**City of Bellevue
Development Services Department
Land Use Staff Report**

Proposal Name: Hansen Rockery

Proposal Description: Land Use review to allow a rockery constructed without a permit to remain within a steep slope critical area associated with code enforcement 11-122879-EA.

File Number: 12-105651-LO

Figure 1

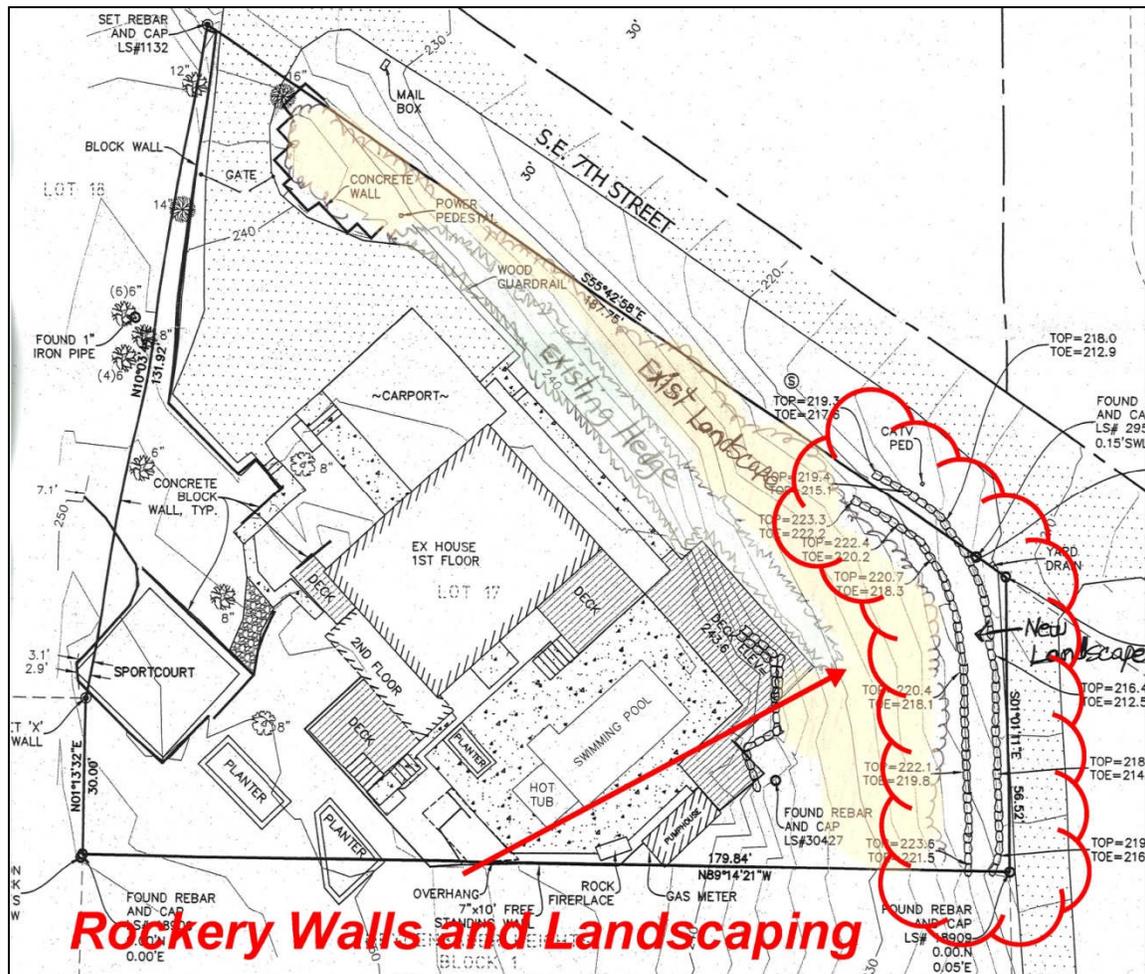
The applicant constructed a tiered rockery wall within a steep slope critical area, near the toe-of-slope and partially within City right-of-way along SE 7th Street without a permit. In addition, the rockery is within a required structure setback and is over 30 inches in height. To remain the rockery must be 30 inches or less in height and must obtain approval of a Critical Areas Land Use Permit to allow modification of a steep slope critical area for the rockery and intended landscaping. A subsequent clearing and grading permit is also required. This review is required to address code enforcement 11-122879-EA. See Figure 1 below for a site plan showing the rockery walls.

- 3. Rockery Height:** The rockery walls shall be 30 inches or less measured from finished grade.

Attachment 1

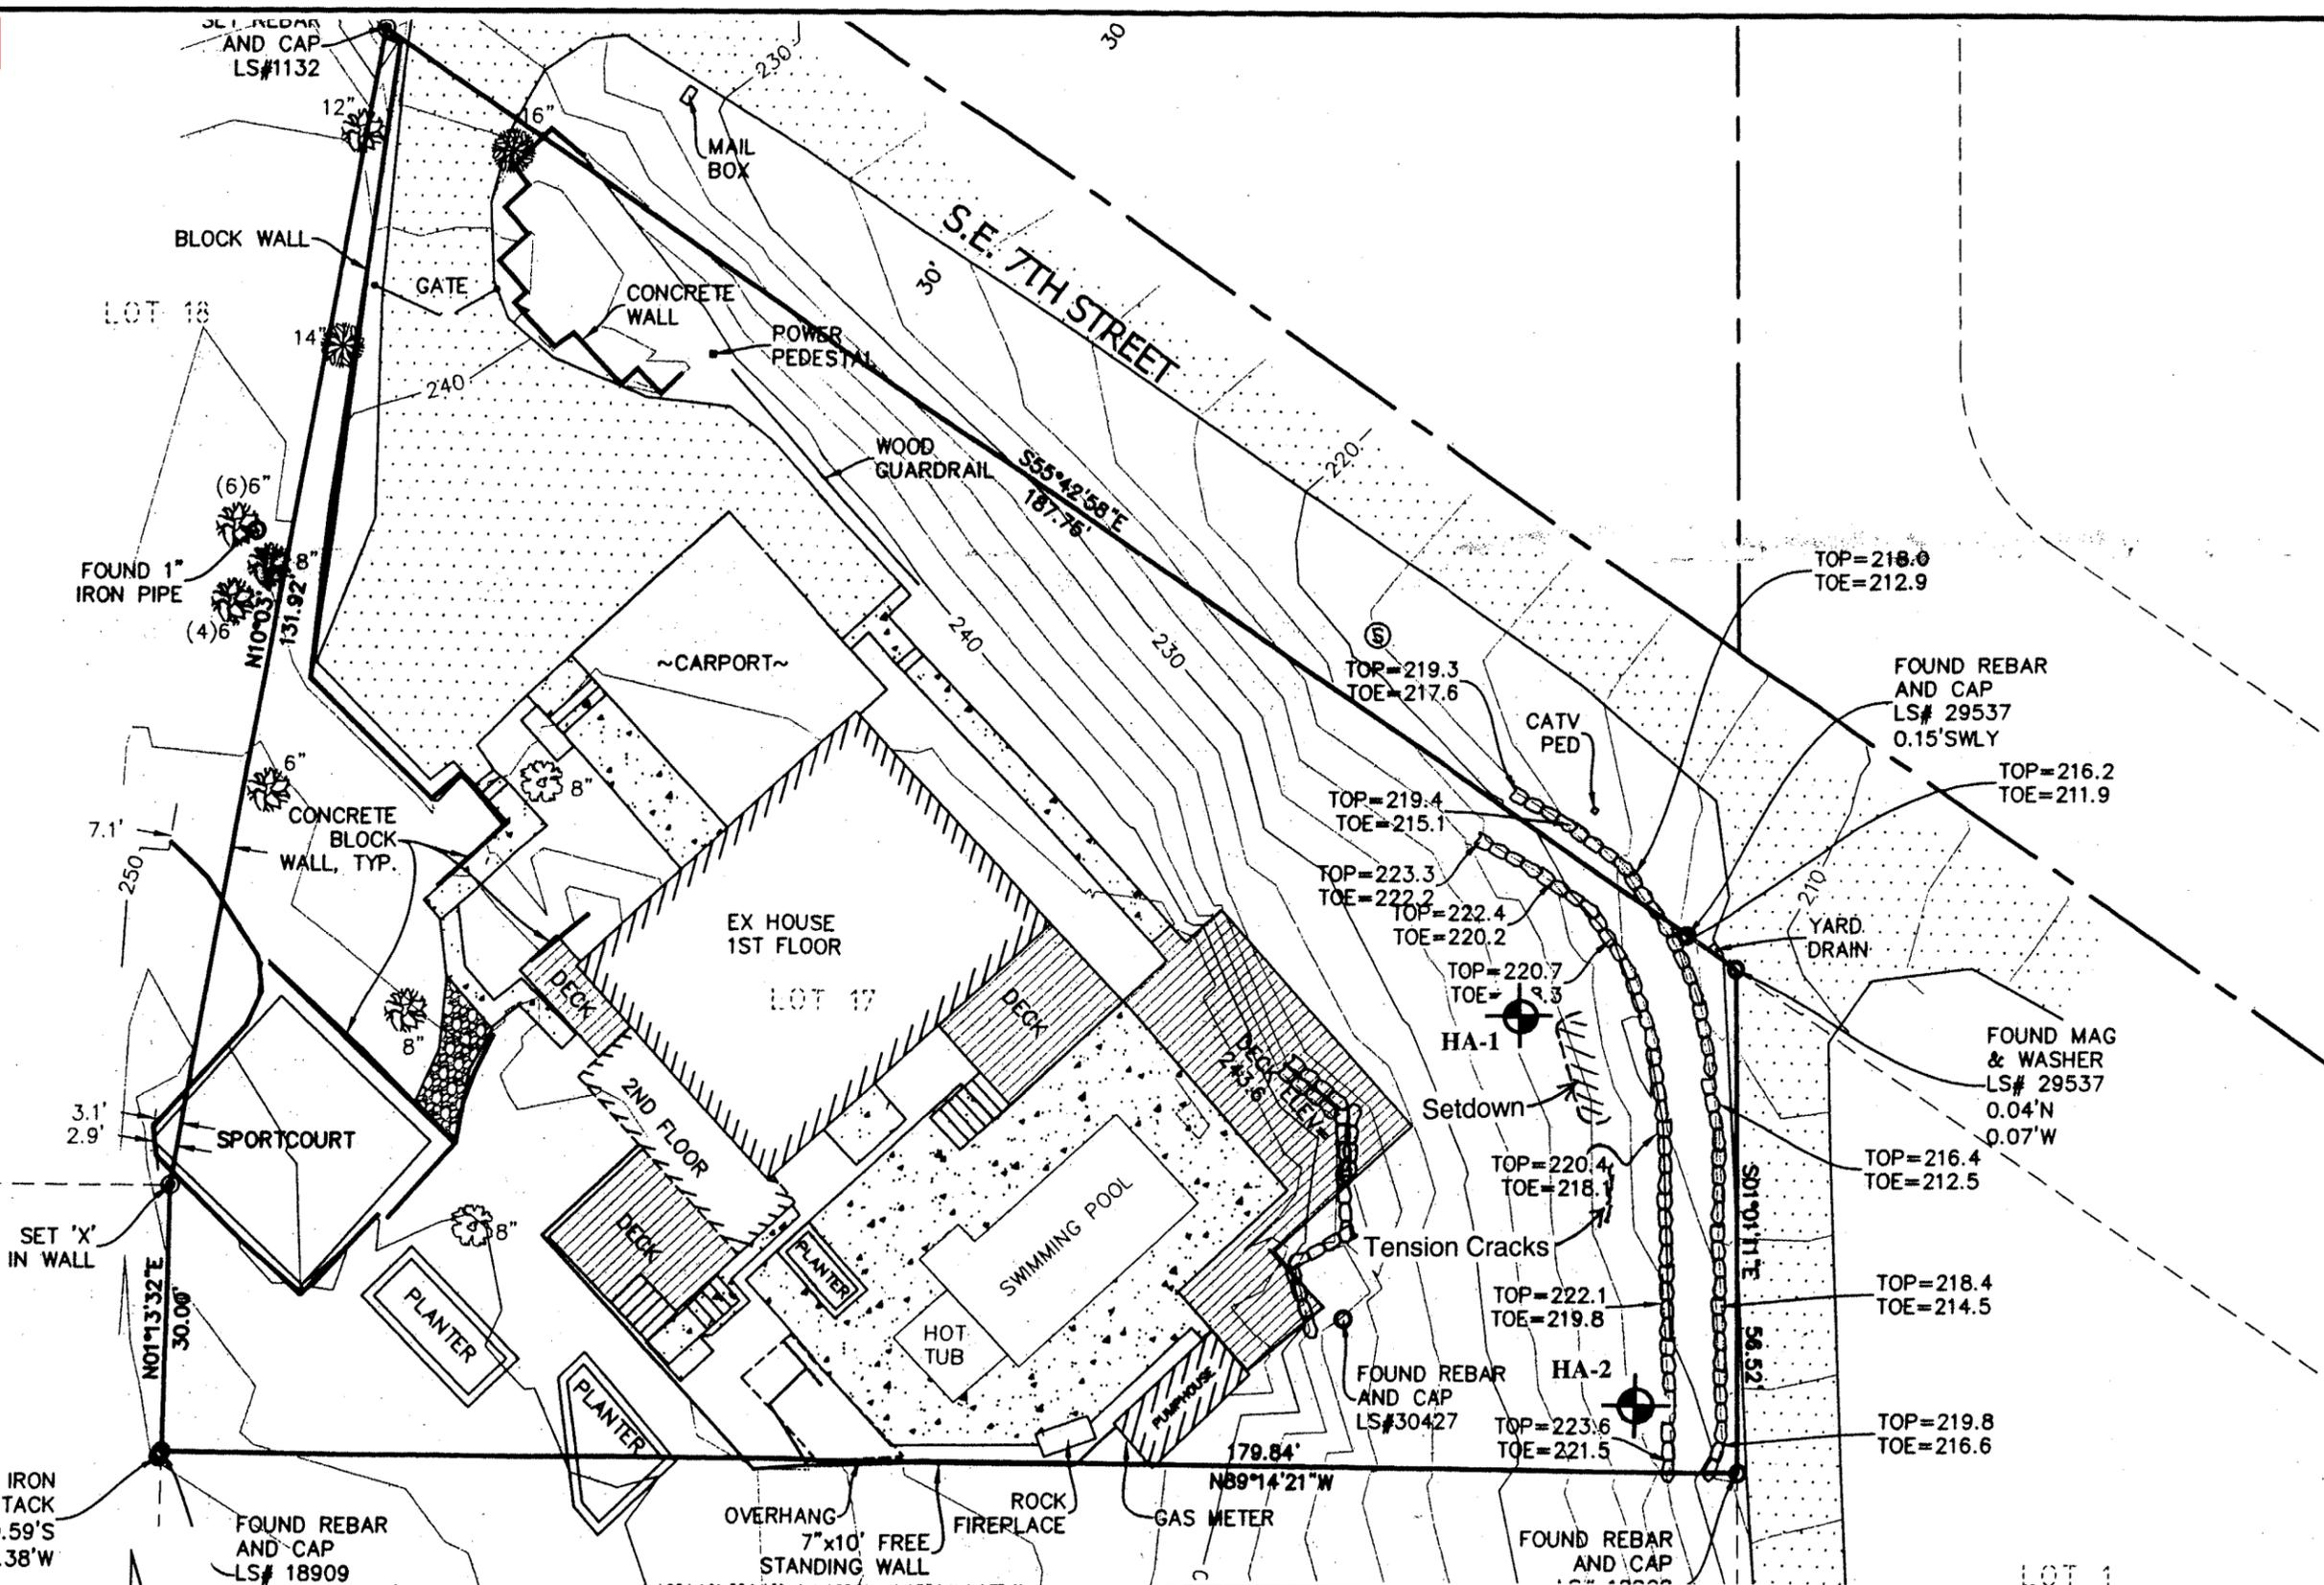
constructed rockery walls. The walls are located in a required structure setback and shall be 30 inches or less in height measured from finished grade. The plans submitted generally demonstrate conformance with zoning dimensional standards, however conformance will be verified during building permit review and inspection. **See Conditions of Approval in Section X of this report.**

The applicant must obtain a clearing and grading permit and any other required development permits. A right-of-way permit is required for the rockery wall to be located within City right-of-way. **See Conditions of Approval in Section X of this report.**

- 2. Right-of-Way Permit:** Approval of permit 11-122904-TH is required in order for the rockery walls to remain within City right-of-way.

Attachment 2

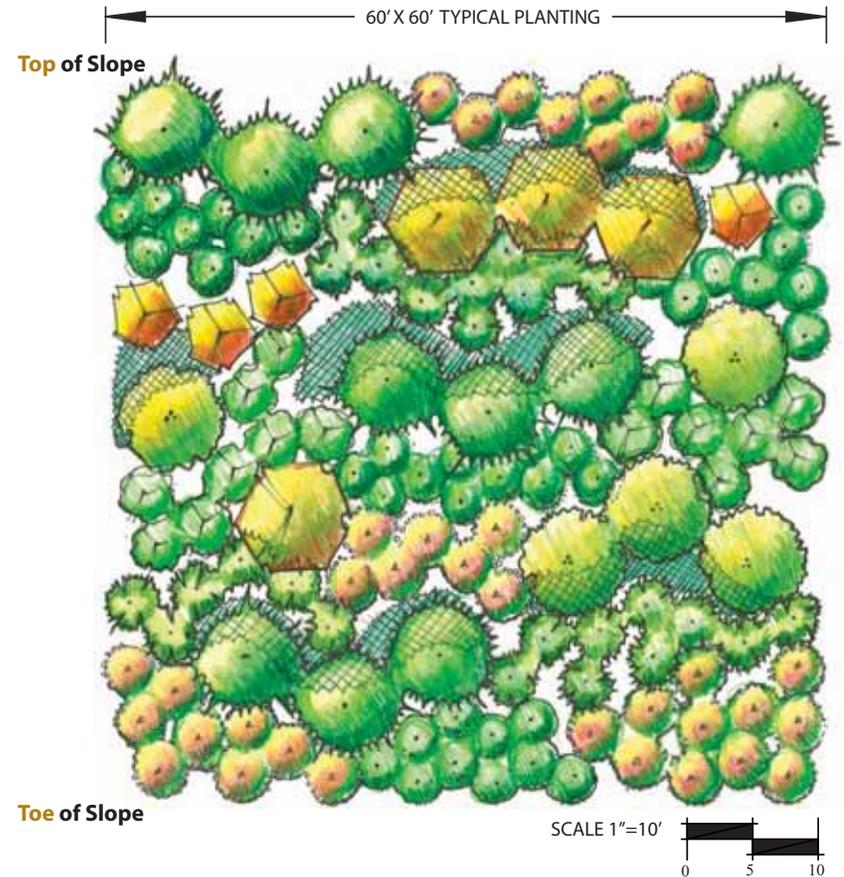
least two other species of native shrub vegetation as found on the planting template for steep slope critical areas in the Critical Areas Handbook are required to be included in the plan. The planting template can be found as attachment 2 to this report. **See Conditions of Approval in Section X of this report.**

- 6. Native Plants:** In addition to the proposed landscaping replacement the planting shall include at least two species of native shrubs found on the City's planting templates for steep slopes in the Critical Areas Handbook found as attachment 2. Other native species can be used if desired, provided they are not ornamental varieties. The selected native plants shall be shown on the plans for the clearing and grading permit. The native plants should have a density similar to the planting template requirements.
